STATEMENT OF ENVIRONMENTAL EFFECTS

**SECTION 4.56 APPLICATION TO MODIFY CONSENT GRANTED TO
DEVELOPMENT APPLICATION DA2021/1408 FOR DEMOLITION OF EXISTING
DETACHED DWELLING AND ERECTION OF A PART 2/PART 3-STOREY
DETACHED DWELLING, CARPORT, BOATSHED, SITE WORKS AND
LANDSCAPING**

**16 ADDISON ROAD
MANLY**

October 2023

BOAT SHED PLAN 1:50

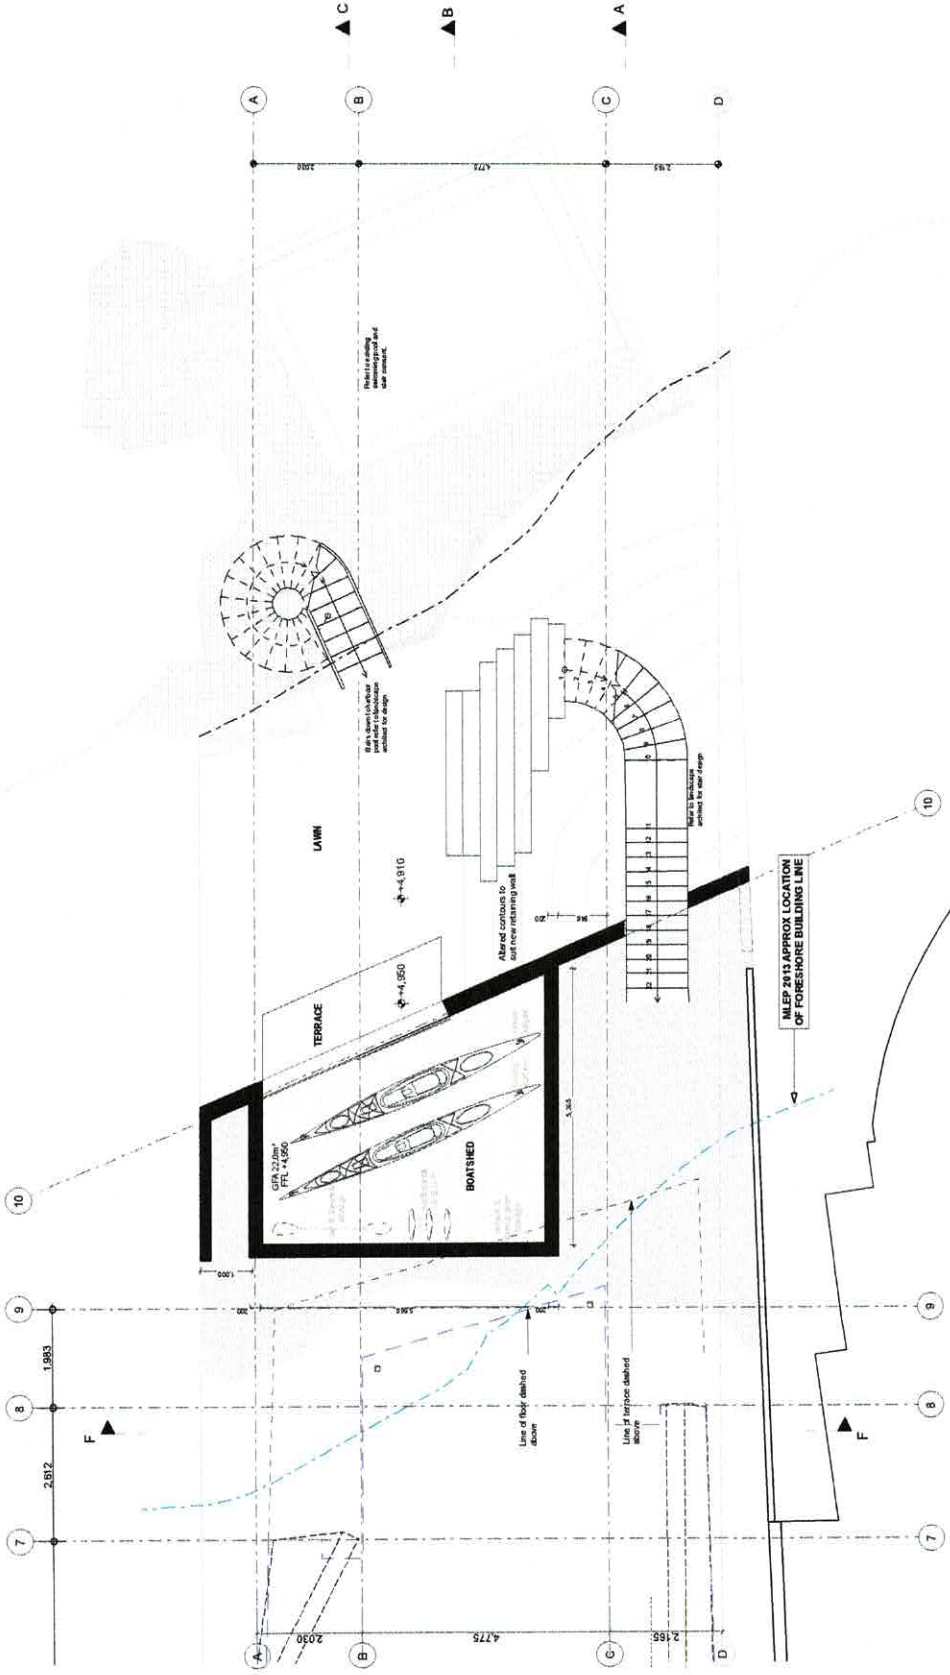
1.3 Boatshed Plan

- 01. No change to boatshed and landscaped foreshore areas.

LOWER FLOOR PLAN 1:50

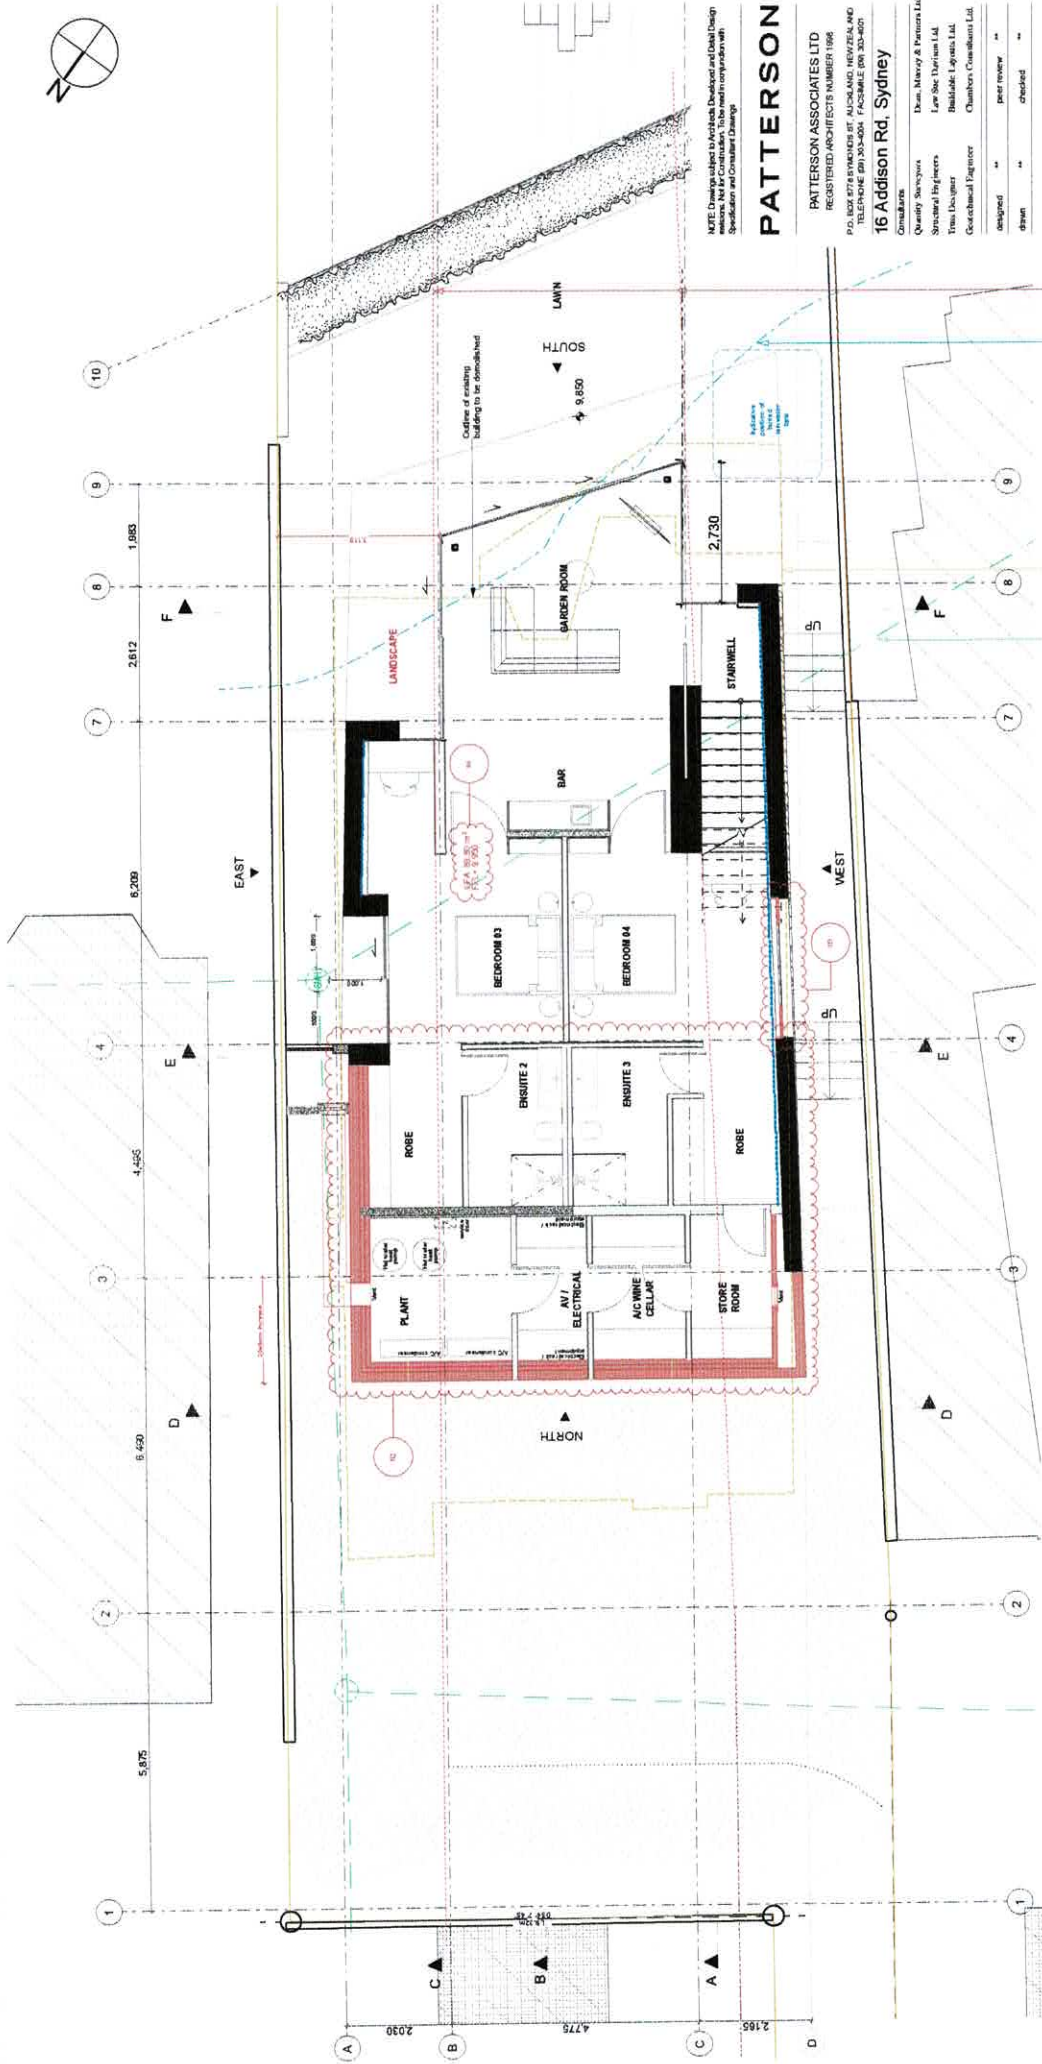
1.4 Lower Floor Plan

- 02. Basement excavation extended to 2046 mm to the north to allow for additional plan equipment & store area, ensuite layout altered.
- 03. Window to bedroom 04 in western façade increased in length by 1.0m and 0.5m in height
- 16. GFA increased from 84.3m² to 89.8m²

GROUND FLOOR PLAN 1:50

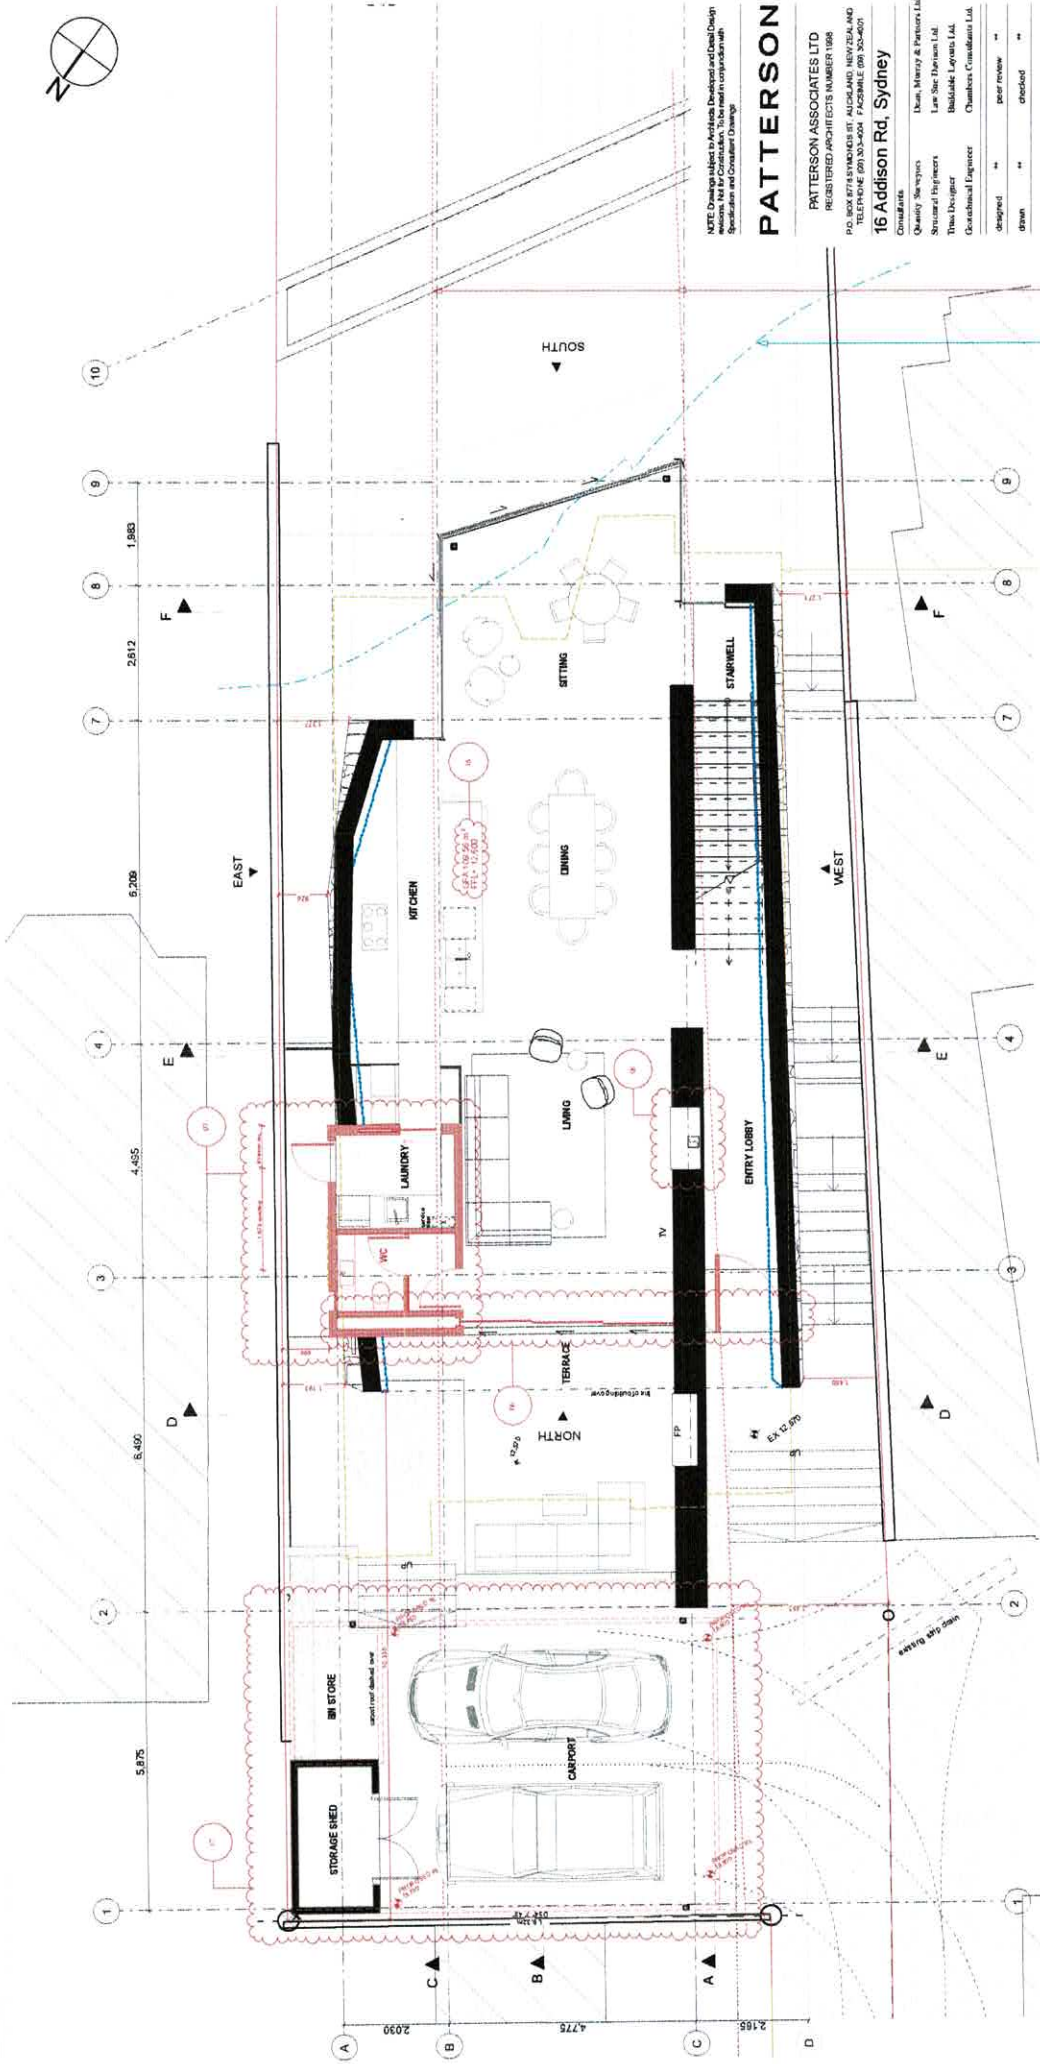
1.5 Ground Floor Plan

- 06. The sliding glazed doors accessing the north terrace have been moved approx. 1.0m north to allow for a WC on the ground floor. The front door was moved to align with the sliding door.
- 07. The metal clad wall on grid A was extended to the north to provide additional area for the WC. Opaque glass window added.
- 08. Approved internal gas fireplace replaced with solid fuel fireplace in same location.
- 16. GFA increased from 106.4m² to 109.56m²
- 17. Carport slab level raised slightly to allow for existing drainage serviced and boundary fencing

ROOF PLAN 1:50

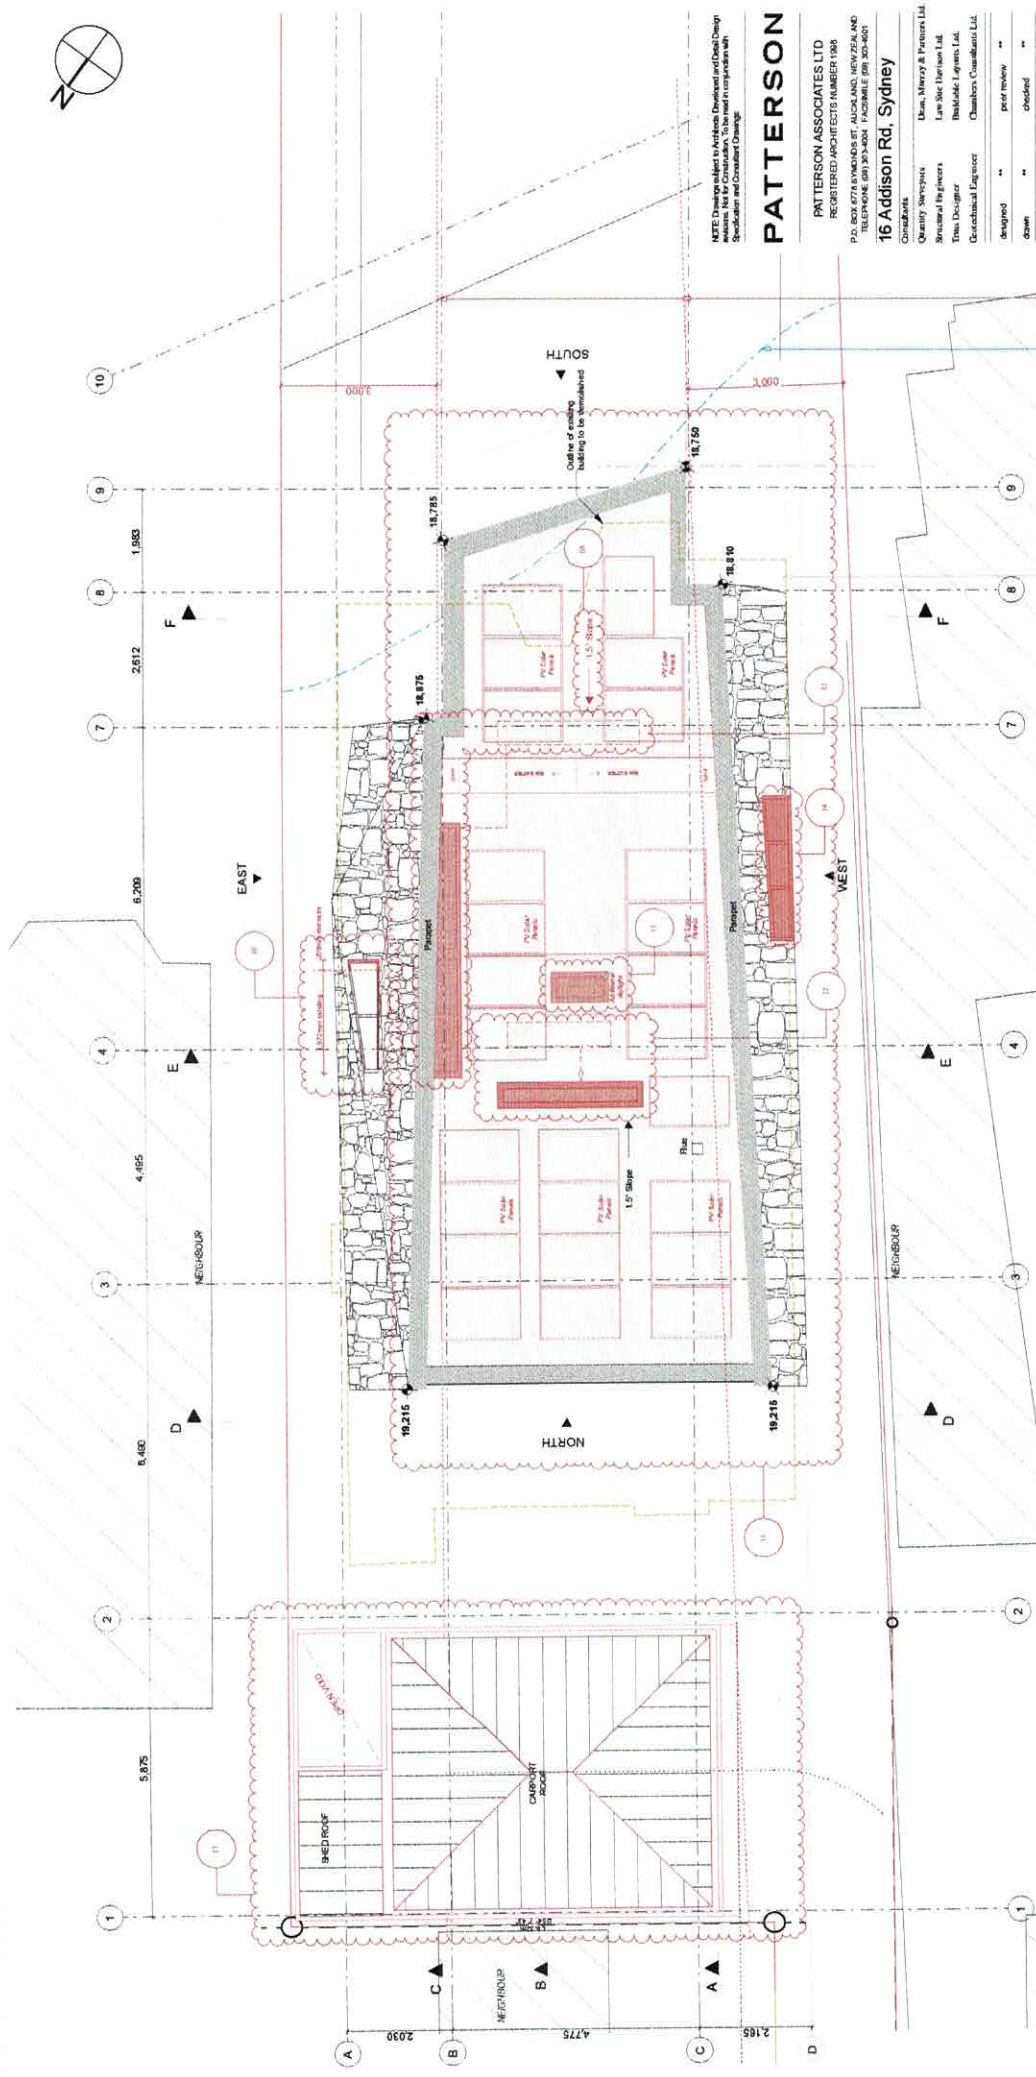
1.7 Roof Plan

- 05. Direction of roof slope adjusted between grids 7 and 9 to suit gutter design and roof drainage.
- 10. East facade skylight widened by approx. 200mm.
- 11. PV solar panels added to roof.
- 12. Relocated skylight in roof over master ensuite bathroom 1 and hallway.
- 13. Additional skylight in roof added over master robe.
- 14. Relocated skylight to stairwell in west façade. Remains same size.
- 17. Carport roof level raised slightly to allow adequate height clearance from slab level.

SOUTH ELEVATION 1:100

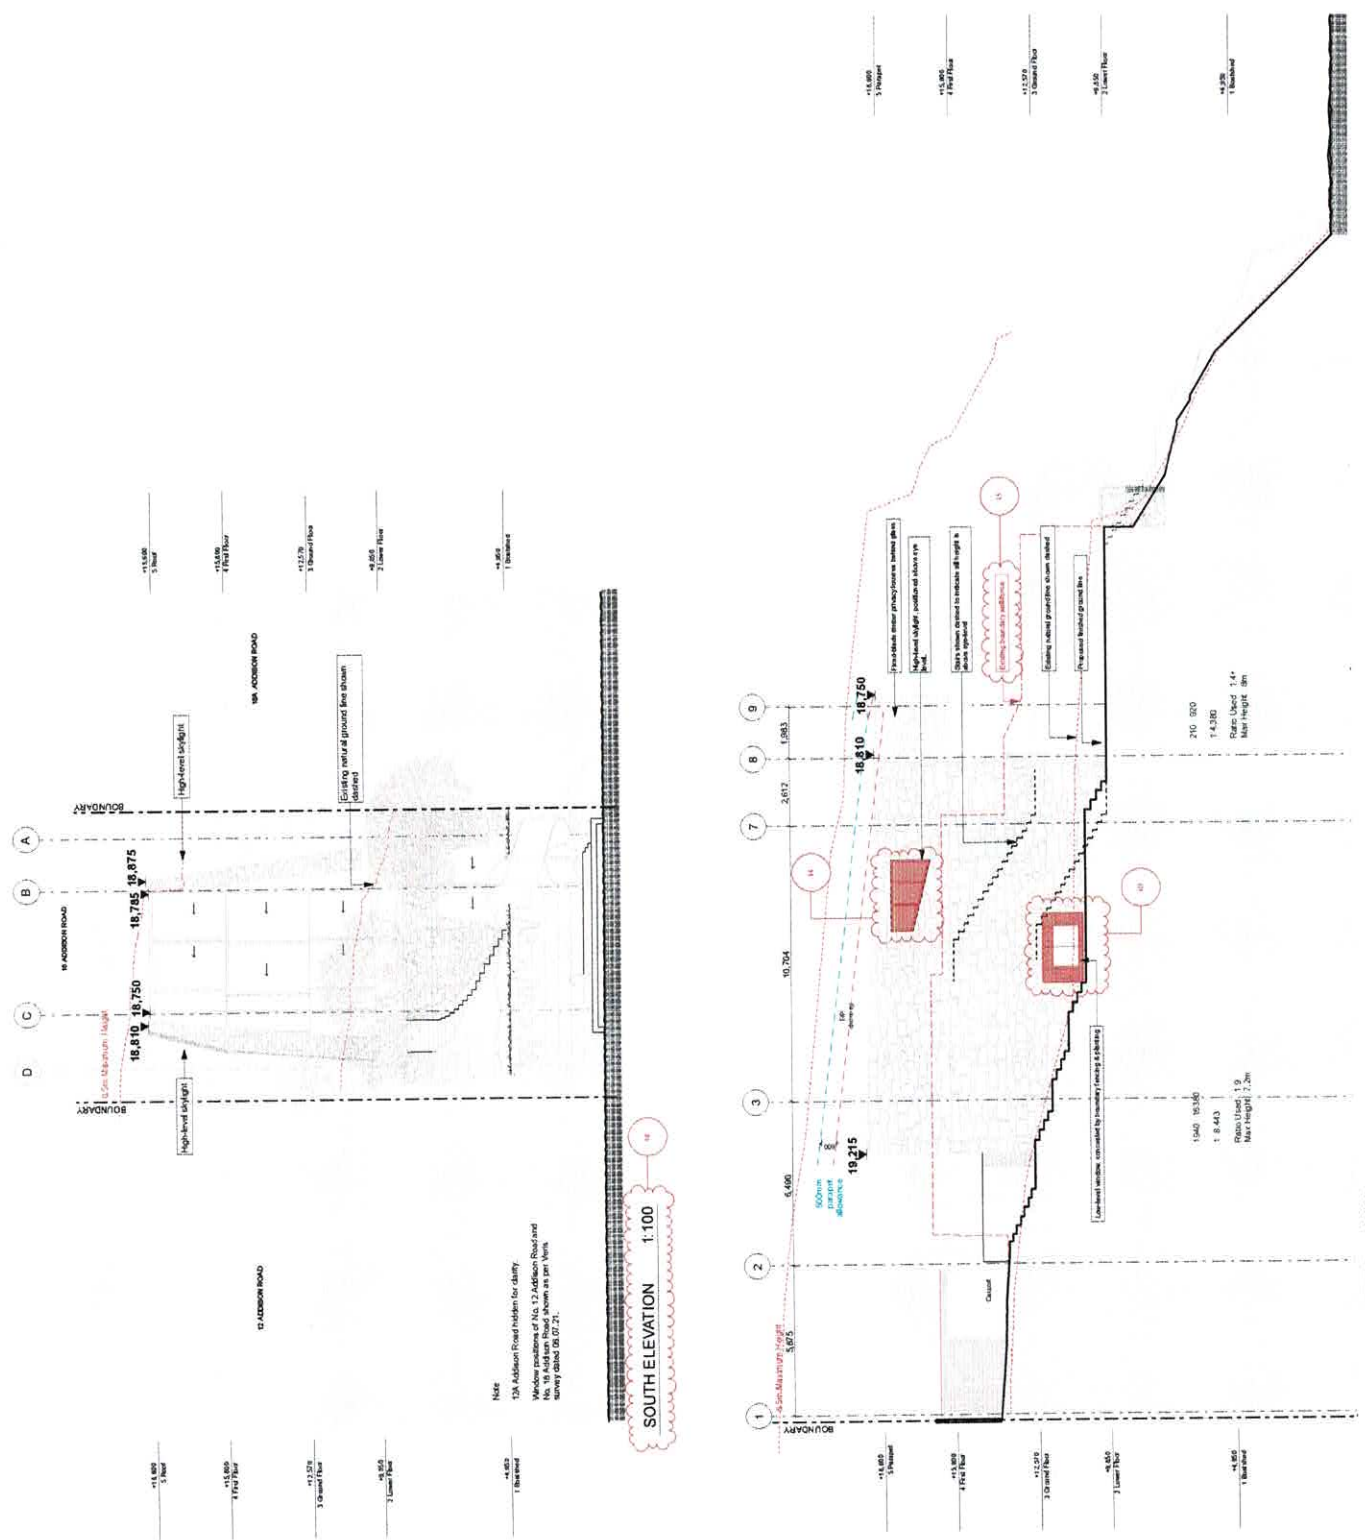
2.1 Elevations

- 03. Window to bedroom 04 in western façade increased in length by 1.0m and 0.5m in height.
- 14. Relocated skylight to stairwell in west façade. Remains same size.
- 15. Outline of existing boundary wall / fence added to drawings.
